**WLD5 - Replacing Hose for Positive Crankcase Ventilation (Workshop Campaign)**

Vehicle Type: **Cayenne (9YA)**

Subject: **Positive crankcase ventilation hose**

*Installation location for positive crankcase ventilation hose.*

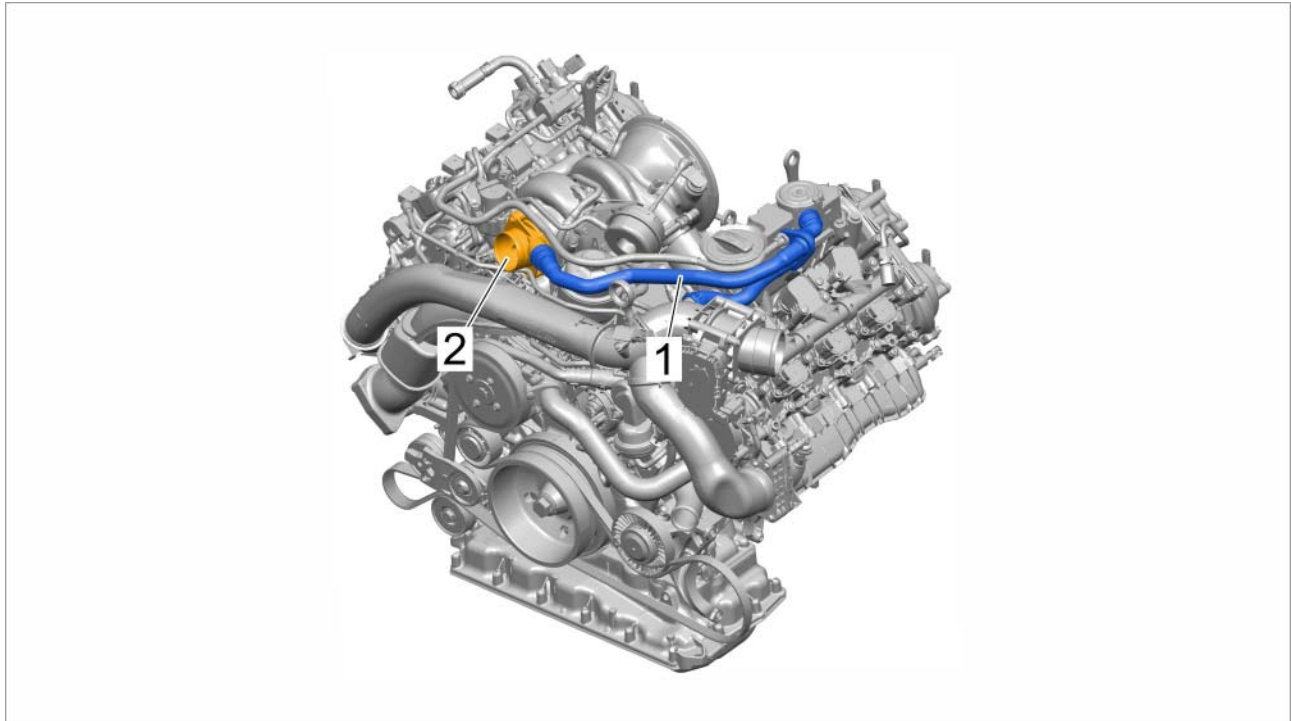
Information: **A part-load valve was installed in the hose for crankcase ventilation on the affected vehicles which has a sealing washer that does not meet the required specifications and could possibly crack when the crankcase pressure rises.**

Consequently, small amounts of engine oil can leak from the oil filler cover into the adjacent engine compartment, resulting in a reduced engine oil level over time. The driver is alerted by an appropriate warning message if the engine oil level is too low.

Remedial Action: Replace positive crankcase ventilation hose with intake manifold.

- 1** – Positive crankcase ventilation hose
- 2** – Intake manifold

*Installation location for positive crankcase ventilation hose.*

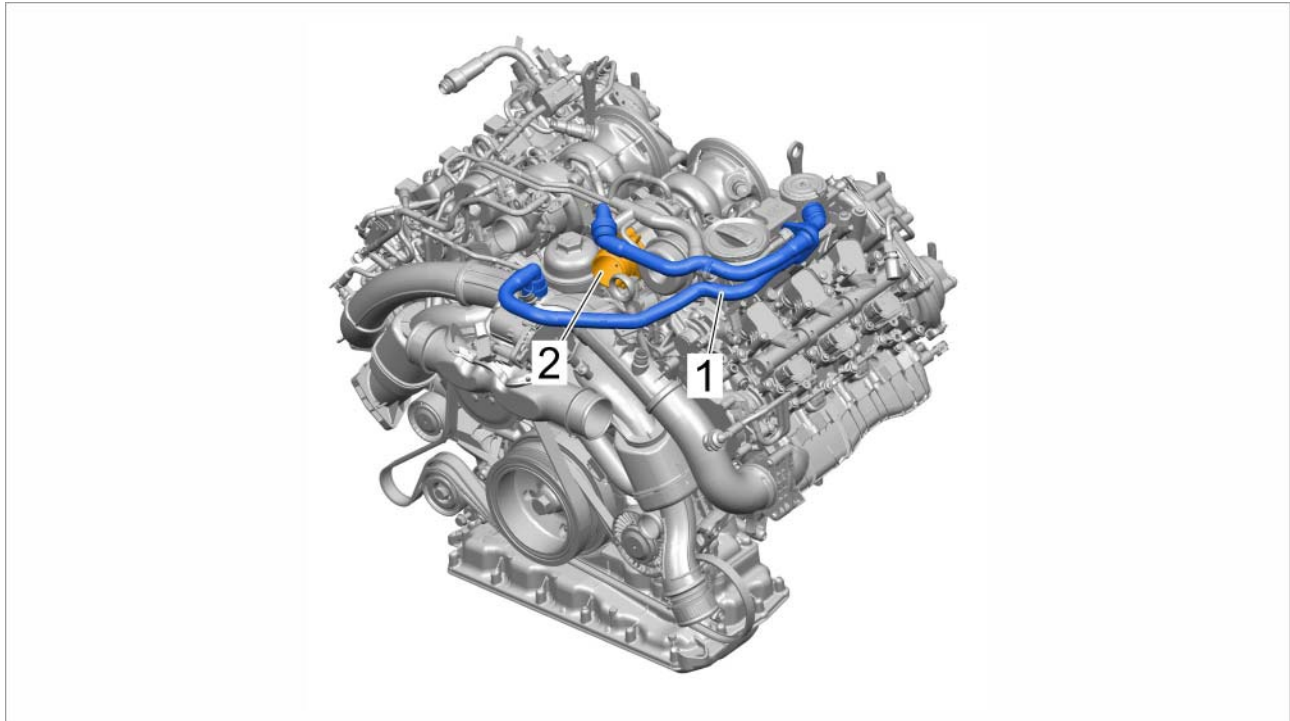
Information: **A part-load valve was installed in the hose for crankcase ventilation on the affected vehicles which has a sealing washer that does not meet the required specifications and could possibly crack when the crankcase pressure rises.**

Consequently, small amounts of engine oil can leak from the oil filler cover into the adjacent engine compartment, resulting in a reduced engine oil level over time. The driver is alerted by an appropriate warning message if the engine oil level is too low.

Remedial Action: Replace positive crankcase ventilation hose with intake manifold.

- 1 – Positive crankcase ventilation hose
- 2 – Intake manifold
